QUALITY ASSURANCE -- NON-CONFORMANCE REPORT

Reference Description: Repairs Performed Without Engineer's Approval**Description of Non-Conformance:**

Dear: Mr. Charles Kanapicki
Attention: Mr. James Bowers
Subject: NCR No. ABF-0010
Contract No: 04-0120F4
04-SF-80-13.2 / 13.9
Job Name: SAS Superstructure
Document No: 05.03.06-000680

Project: SFOBB Self-Anchored Suspension Bridge

LOCATION SKETCH

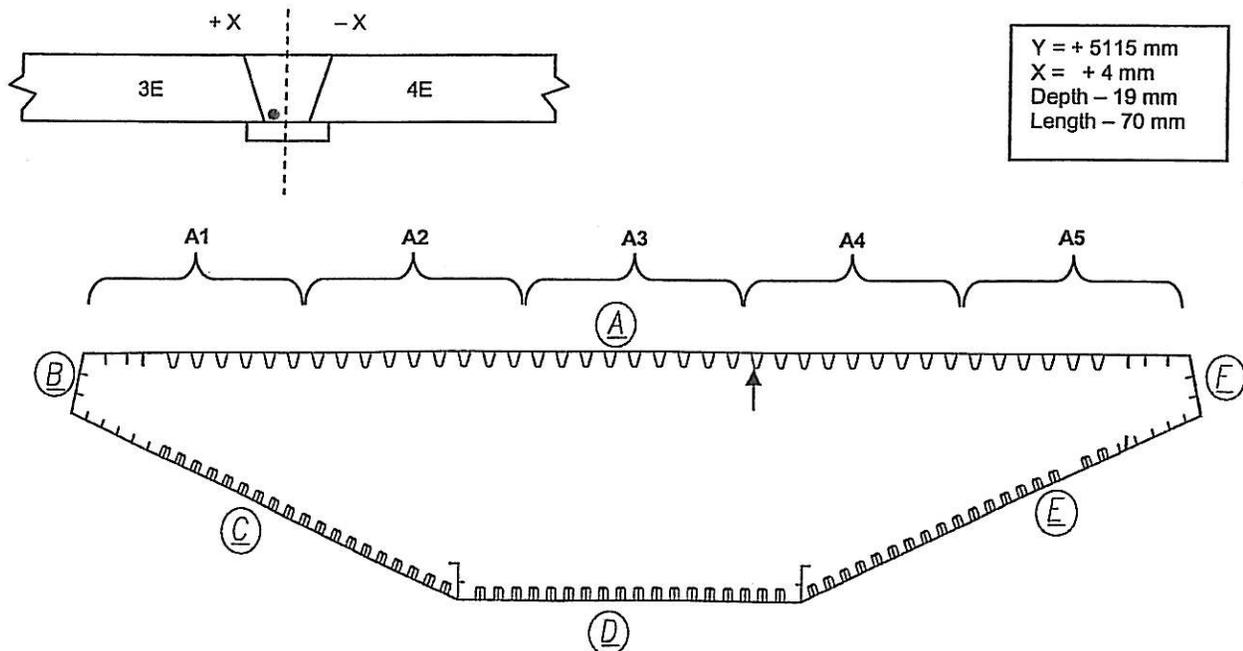
QA inspector observed that the Contractor repaired a 15mm crack in weld 3E/4E-A5 without the prior approval of the Engineer.

Incomplete fusion of weld metal to base metal @ root

Reference Resolution: Attached are the final VT and NDE reports for the weld in question.
